Access Compliance Report Public Rights-of-Way (Curb Ramps)

Main Street: MONTECITO_RD		Cross Street: BOSTONIAN_DR		Location:	NE
---------------------------	--	----------------------------	--	-----------	----

ADA ID: RPRK211215133137	Ramp Type: Type 4 - Parallel	Initial Pass/Fail: Fail	Overall Compliance: No	Severity Score:	2
--------------------------	------------------------------	-------------------------	------------------------	-----------------	---

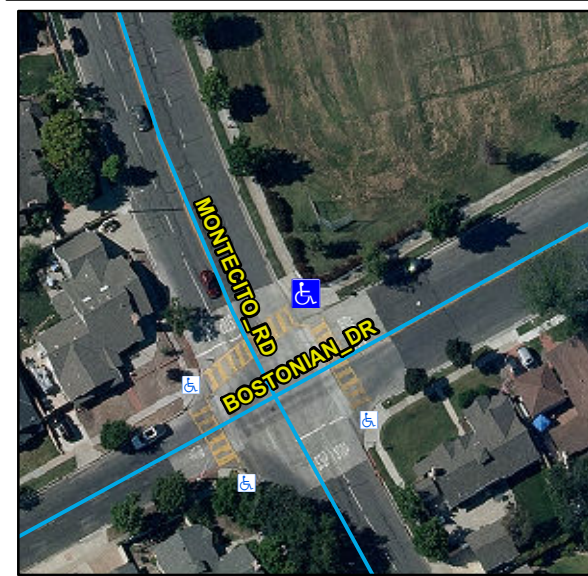
Compliance	Description	Data	Compliance	Description	Data
N/A	Ramp Length LT (in)	98	N/A	Ramp Length RT (in)	102
Yes	Ramp Width LT (in)	96	Yes	Ramp Width RT (in)	96
Yes	Ramp Run Slope LT (%)	5.8	Yes	Ramp Run Slope RT (%)	4.4
Yes	Ramp Cross Slope LT (%)	1.9	No	Ramp Cross Slope RT (%)	3.5
N/A	Landing Present	N/A	N/A	DWS Provided	N/A
N/A	Landing Length (in)	N/A	N/A	DWS Contrast	N/A
N/A	Landing Width (in)	N/A	N/A	DWS Length (in)	N/A
N/A	Landing Run Slope (%)	N/A	N/A	DWS Full Width	N/A
N/A	Landing Cross Slope (%)	N/A		DWS Offset Type	N/A
N/A	Landing Movement Obstructed?	N/A	N/A	DWS Offset Left (in)	N/A
	Landing Movement Type	N/A	N/A	DWS Offset Right (in)	N/A
N/A	Landing Shared	N/A			
N/A	Clear Space	Yes			
N/A	Clear Space To Crosswalk (in)	48			
N/A	Marked Crosswalk 1	Yes	N/A	Marked Crosswalk 2	Yes
	Crossing 1 Direction	W		Crossing 2 Direction	S
	Marked Crosswalk 1 Width (in)	144		Marked Crosswalk 2 Width (in)	144

Remove & Replace Curb Ramp With Two New Directional Ramps or Equivalent.

R304.5.3, STD 1115
